ENGINEERING CHANGE NOTICE NO. 05397		SHEET 1 OF 1	
DWG NO. 647.7700	REV: A	PREPARED BY T. CROSS	DATE: 05/02/16
DWG TITLE: STRUT ASSY			
APPROVED BY: ENGR <i>[Signature]</i>	MFG <i>[Signature]</i>	QC <i>[Signature]</i>	EFF: <i>[Signature]</i>
REASON: REVISED DIMENSION			EFFECT ON DWG ☐ INC. ☒ UNINC.
			ECR: 16-028
			ACTION LIST: 1.

DWG TITLE: STRUT ASSY

REV 8 30726 DWG NO. 647.7700 SHEET 1 OF 2

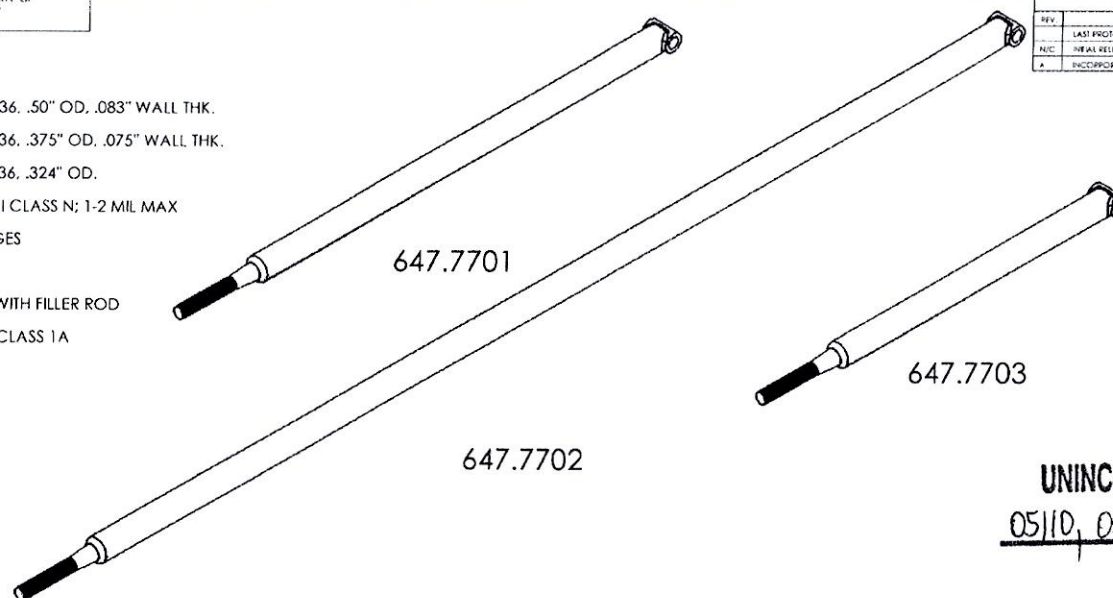
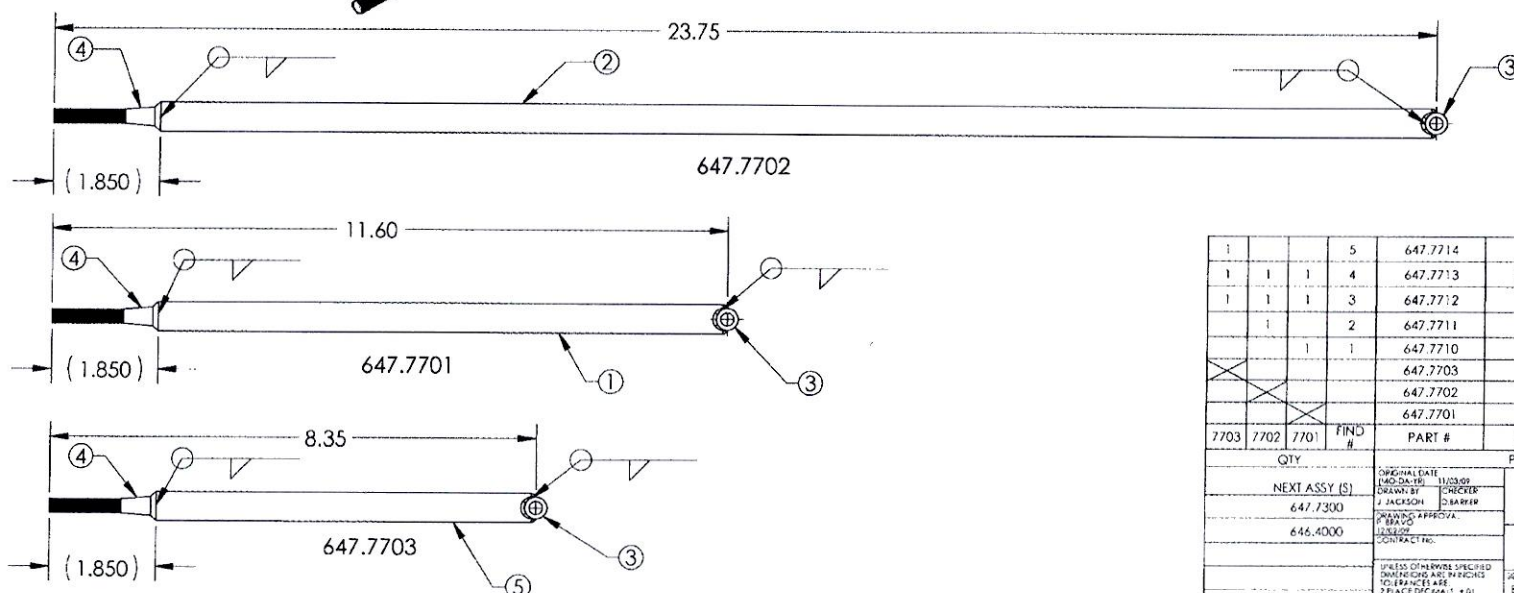
REASON: REVISED FINISH CALLOUT AS PER ECR 15-209

SHEET 1, NOTES IS:

- 1 MATERIAL: 4130 STEEL PER AMS-T-6736, .50" OD, .083" WALL THK.
- 2 MATERIAL: 4130 STEEL PER AMS-T-6736, .375" OD, .075" WALL THK.
- 3 MATERIAL: 4130 STEEL PER AMS-T-6736, .324" OD.
- 4 FINISH: PRIME IAW MIL-P-2337J TYPE I CLASS N; 1-2 MIL MAX
5. DEBURR AND BREAK ALL SHARP EDGES
6. IDENTIFY IAW MPP-120.
- 7 WELD IAW MIL-STD-2219. TIG WELD WITH FILLER ROD
- 8 FINISH: CAD PLATE IAW QQ-P-416F CLASS I TYPE II
- 9 MASK THREAD PRIOR TO FINISH
